Pico Branch Library SP 2119
Addendum Number 3
RFP Document

March 6, 2012

Additional Information/ RFI Response

1.1 REVISIONS TO DRAWINGS

Pico Branch Library
Modified MaxWell® Plus Drainage System Detail And Specifications

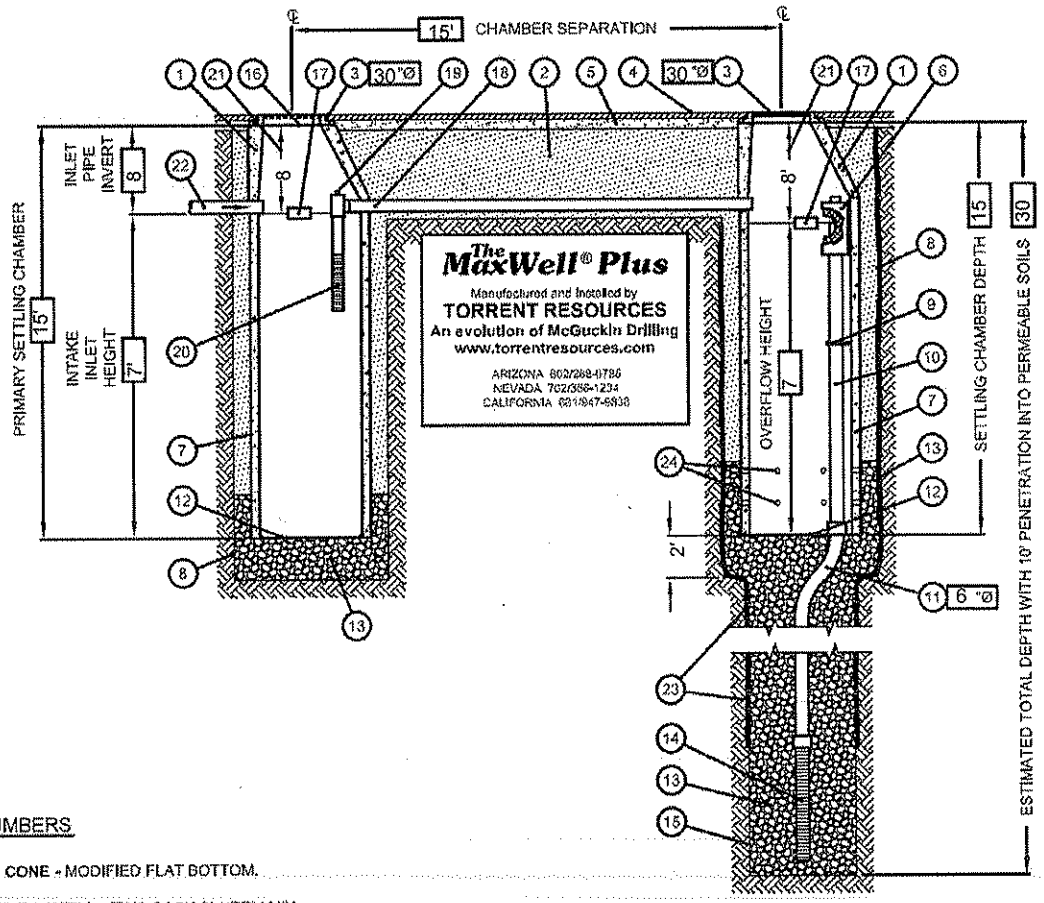
RFI#18: Please refer to sheet C1.20. There appears to be an area of perforated pipe that is labeled SD1, (see below). Please confirm that the note in the cloud should be SD1. Please provide a detail of this area as well as a detail for the drywell system per SD13.ANSWER: SD18 delineates the point of connection between the perforated pipe (Note 22) shown in the landscape plans and the solid pipe (SD1)

ANSWER: SD18 delineates the point of connection between the perforated pipe (Note 22) shown in the landscape plans and the solid pipe (SD1) shown in the Civil Drawings. The Contractor can make the necessary adjustment in the field during construction. See attached detail of the dyrwell system. See attached detail ADD#3-01 of the Modified MaxWell Plus Drainage System.

SIGN TYPE B1

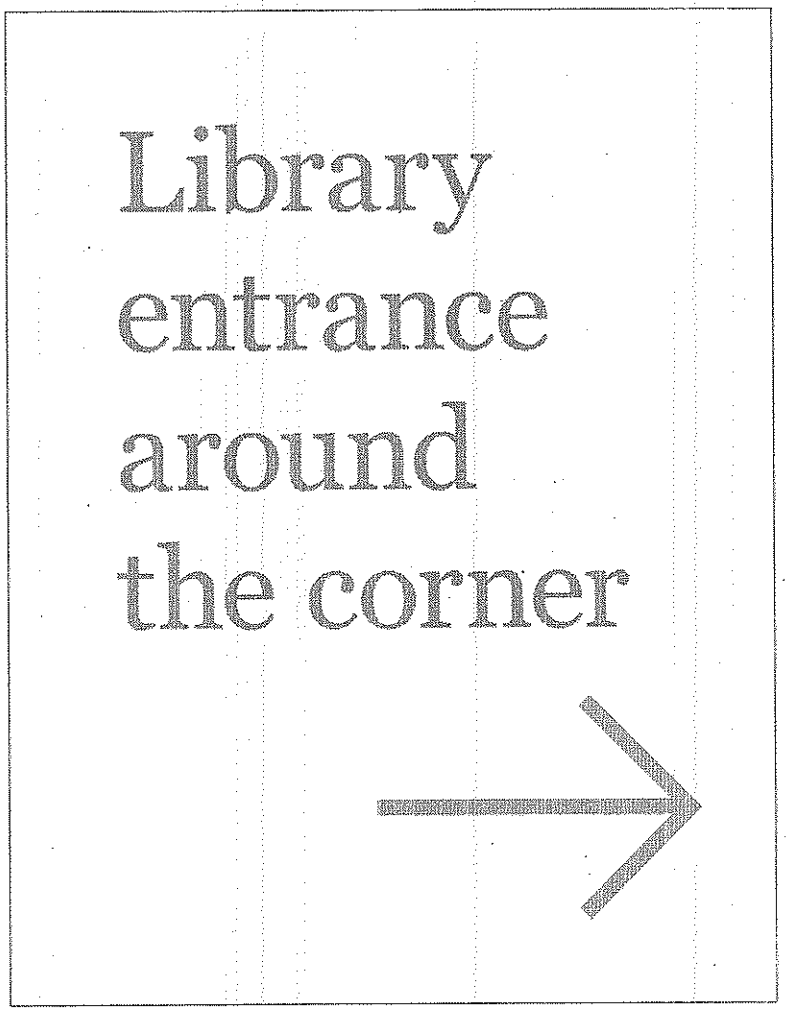
RFI#41: e. Missing drawings and quantities for Sign Type B1
ANSWER: See ADD#3-02 sketch.
f. Missing drawings and quantities for Sign Type C10
ANSWER: See ADD#3-03 sketch.
i. Missing drawings and quantities for Sign Type E7
ANSWER: This signage will be priced as part of the furniture package and will be coordinated with the vendor selected by the city..

22"h x 17"w x 1/8" thick painted aluminum plaque. Paint all faces and edges. Silkscreened copy and art. Radiused corners and eased edges. Paint finishes shall be Mathews Acrylic Polyurethane w/ Mathews Primer and Metal Pre-treatments or equal with a polyure-thane anti-UV clear coat with a 20% lo sheen reflectance. Attach to wall with countersunk tamperproof screws (4 minimum) painted to match surrounding color. Waterproof all building penetrations. Graffiti resistant. Allow for 3 custom colors TBD.
Quantity: 1

SHEET NO.
A1.04

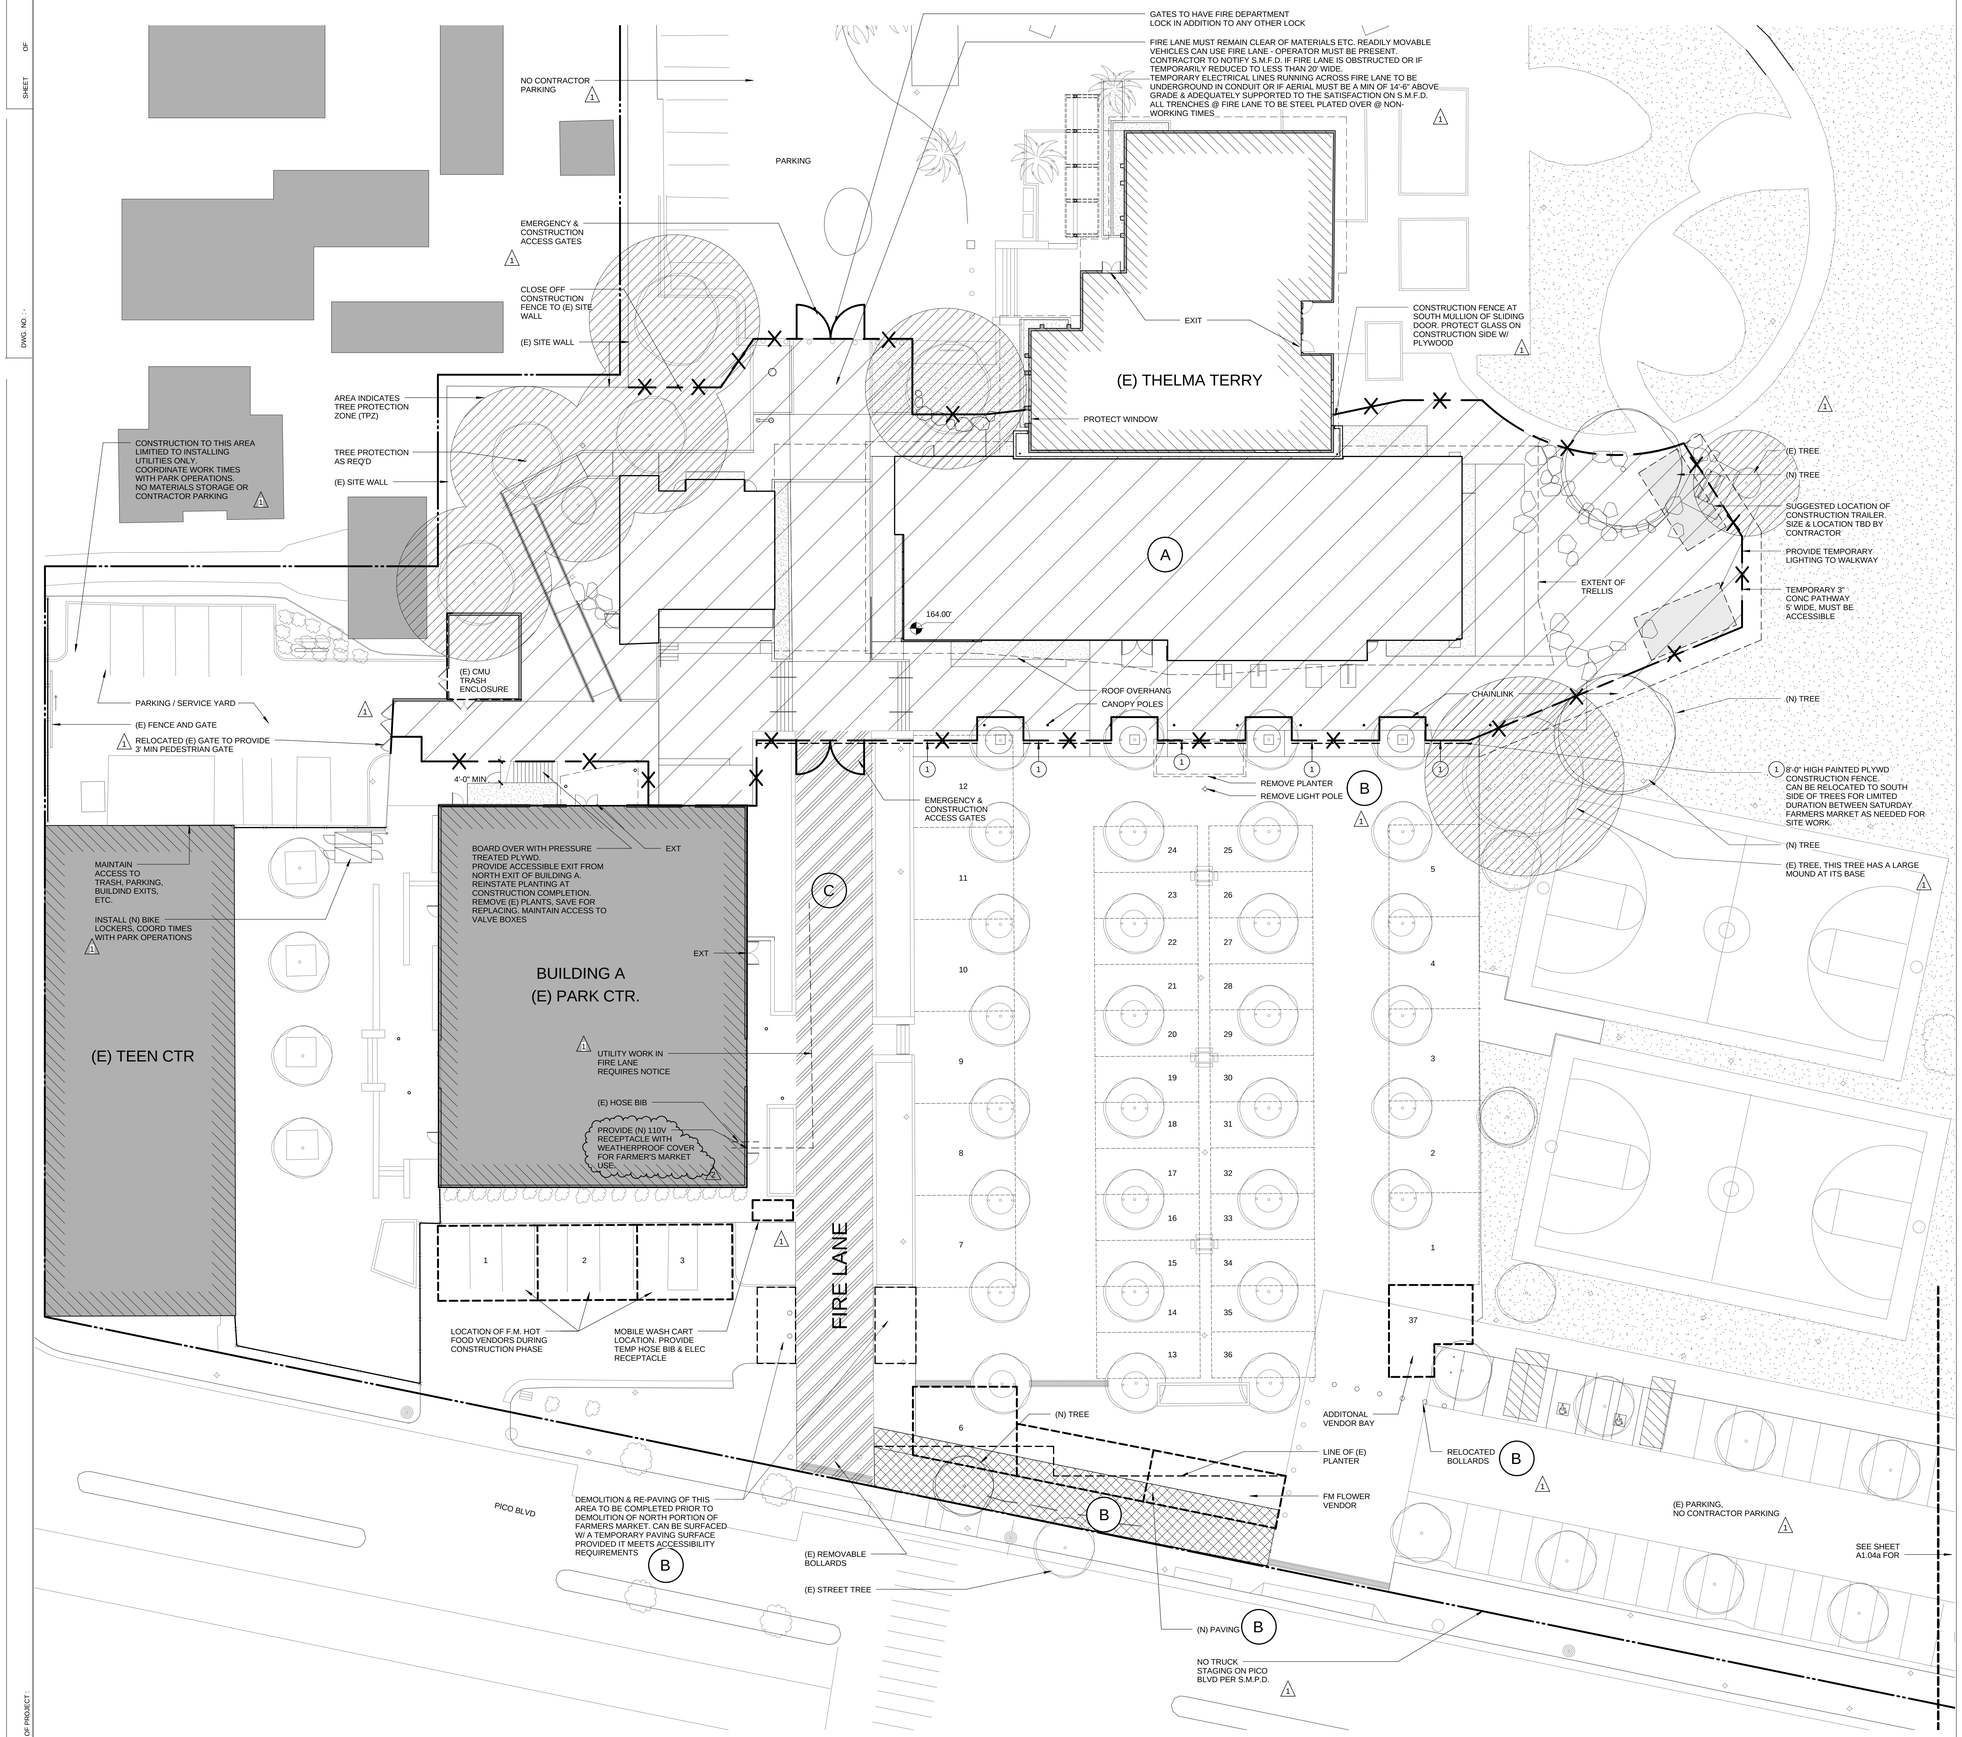
RFI#29: Refer to sheet A1.04. Is a temp hose bib and electrical outlet to be included with the GC's scope? If so, is there a plan indicating the requirements and POC?

ANSWER: A new electrical outlet will need to be provided. See note on Addendum 3 sheet A1.04 for more information. A temporary hose bib does not need to be provided.

SHEET NO.
A2.20

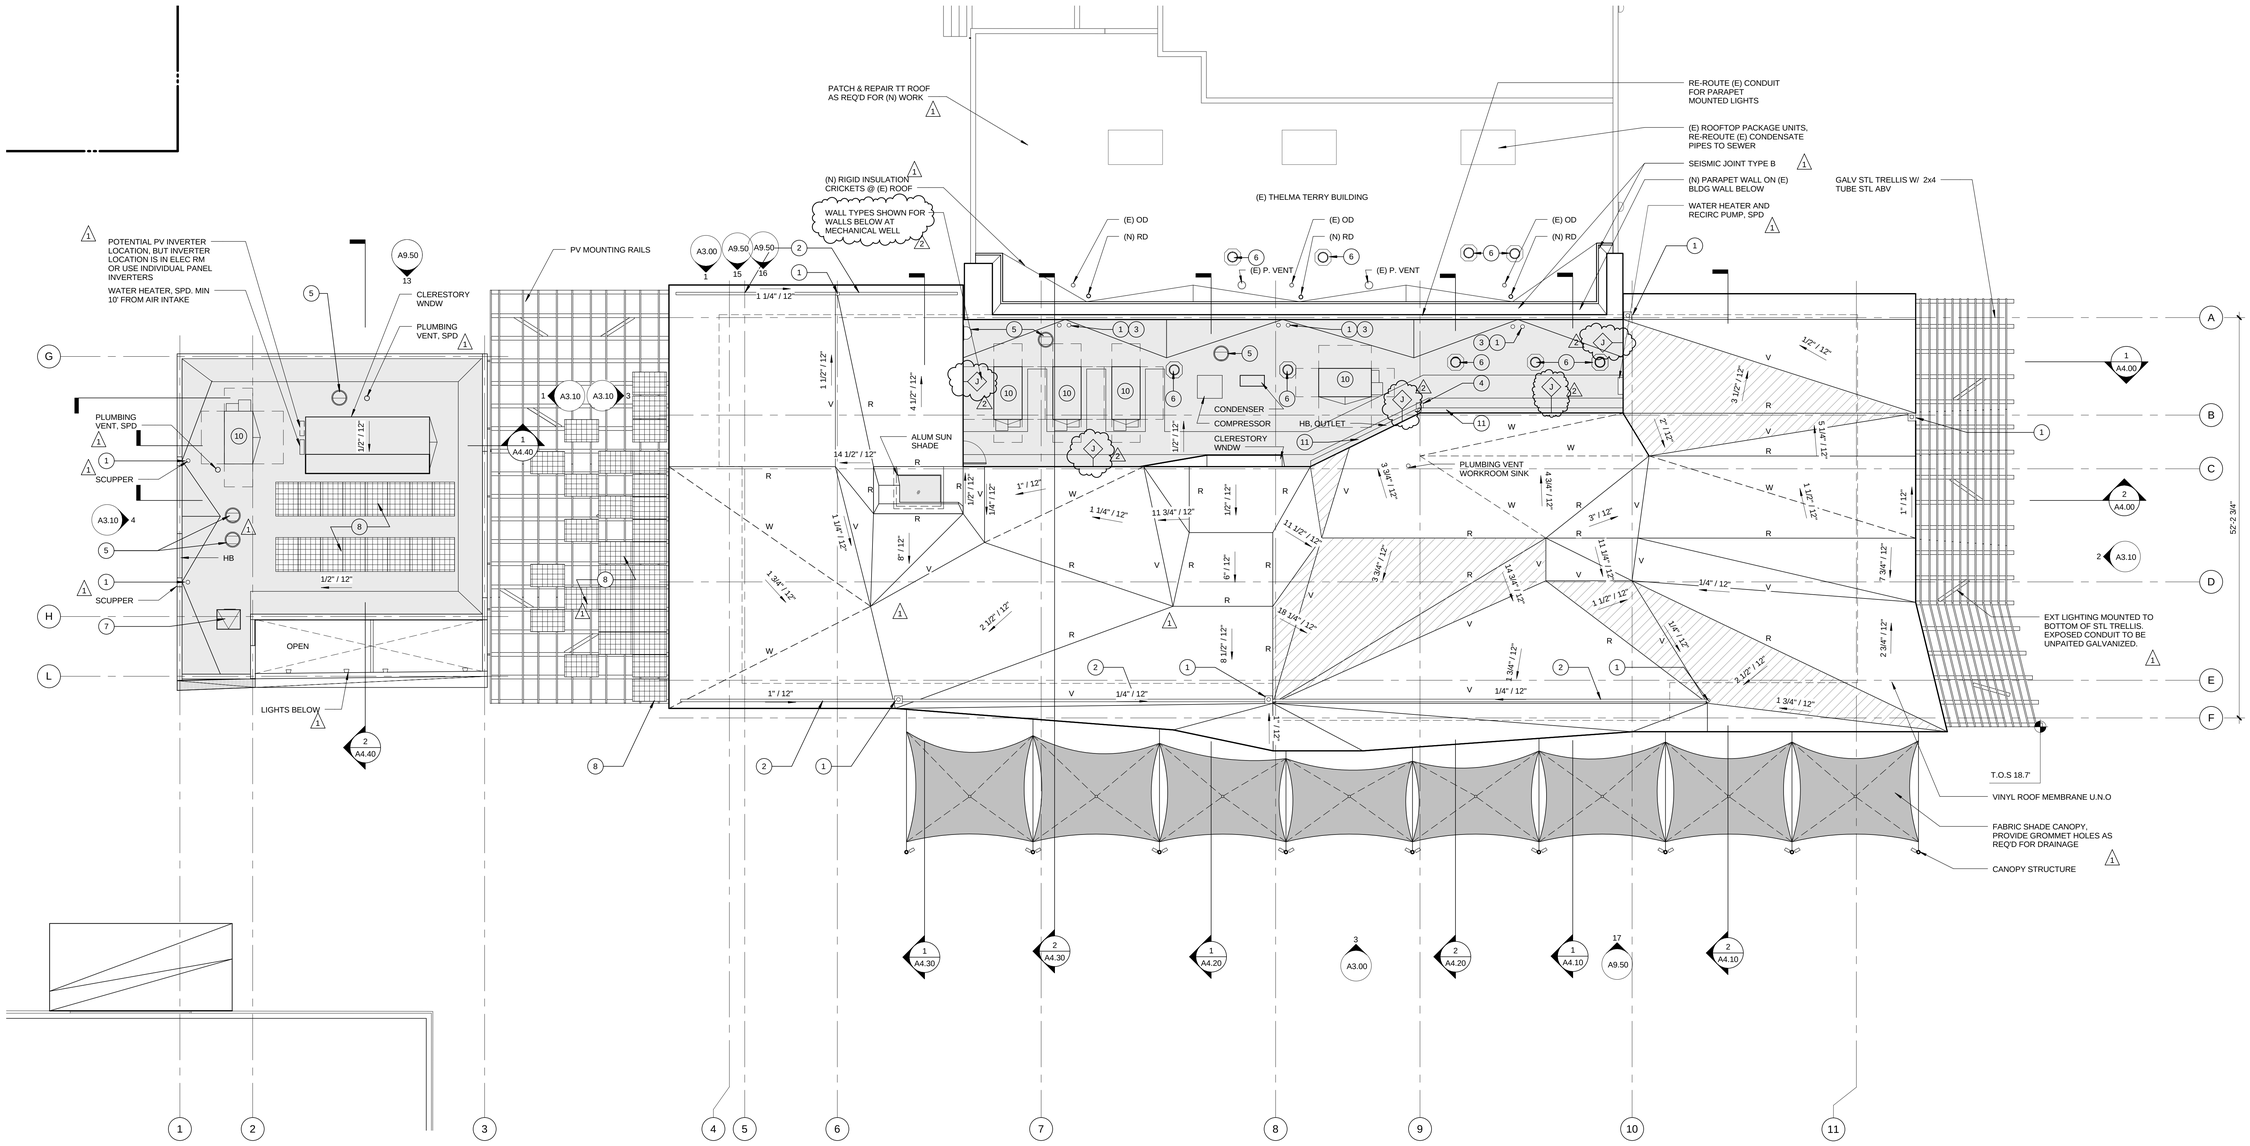
RFI#58: Library roof plan shows recessed gutter. In bldg sections these are not shown. Provide details.
ANSWER: See Addendum 2 drawing 4/A9.20 for gutter detail. See Addendum 3 revised building sections that show recessed gutter locations.

SHEET NO.
A4.10

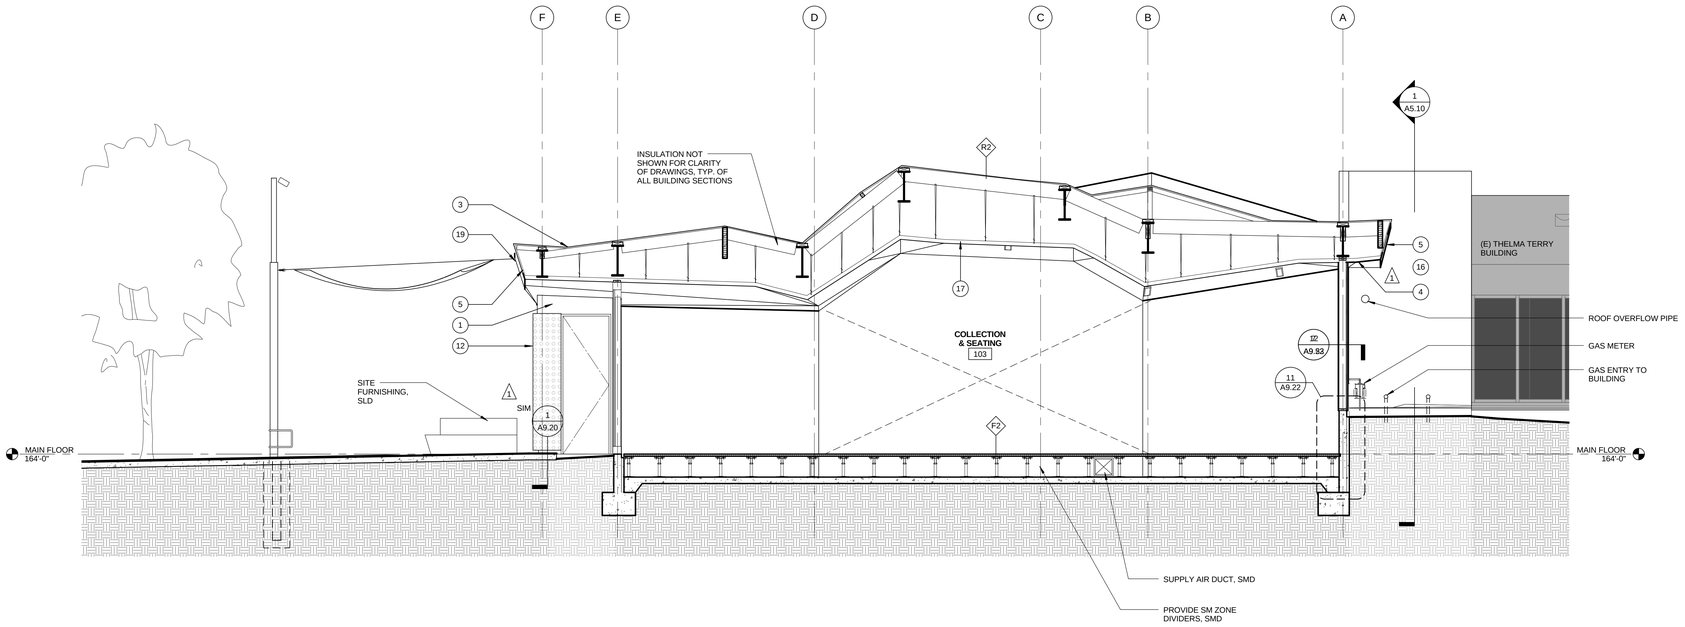
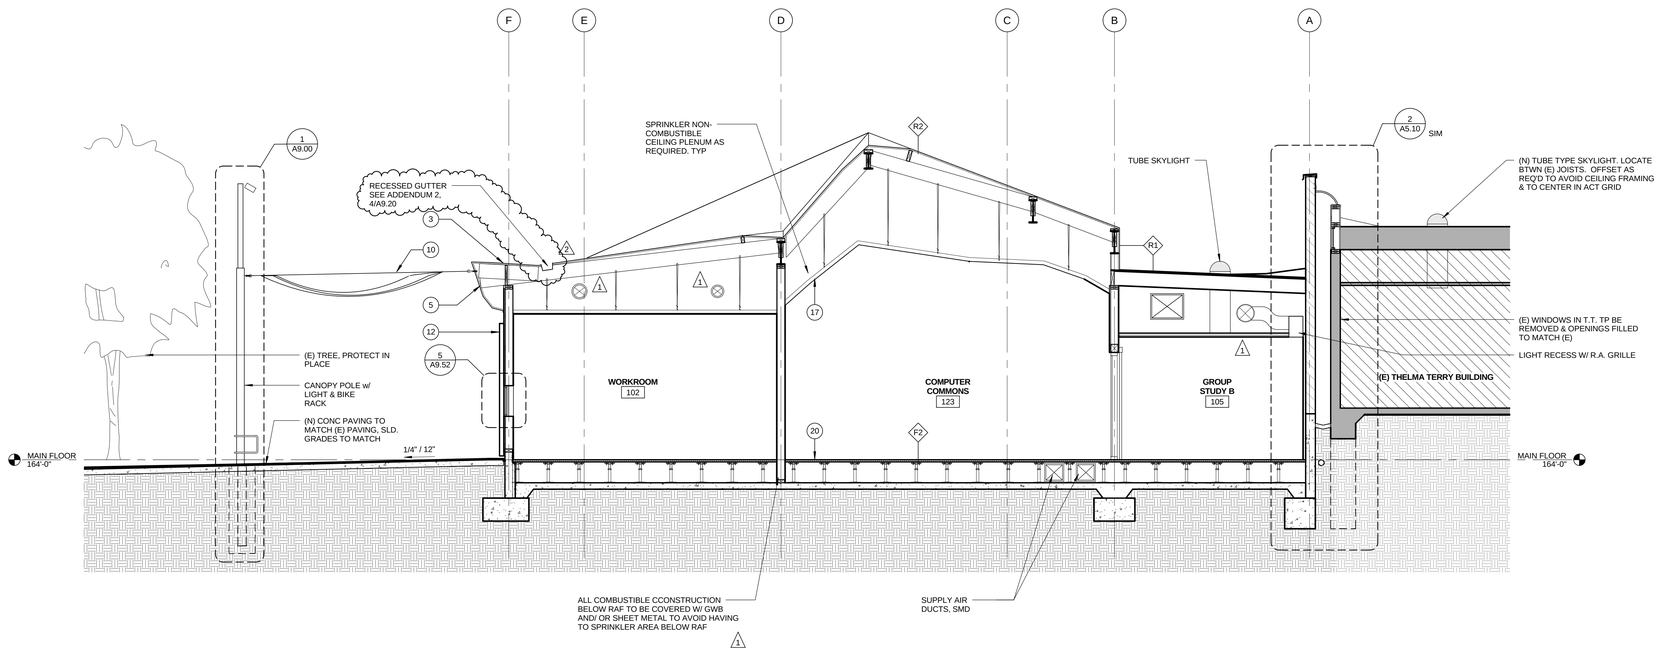
RFI#64: Provide wall IDs the rest of interior walls and walls above Library flat roof.
ANSWER: Interior walls are wall type A unless otherwise noted. See Addendum 3 building sections and sheet A9.30 for clarification on wall type above library flat roof.
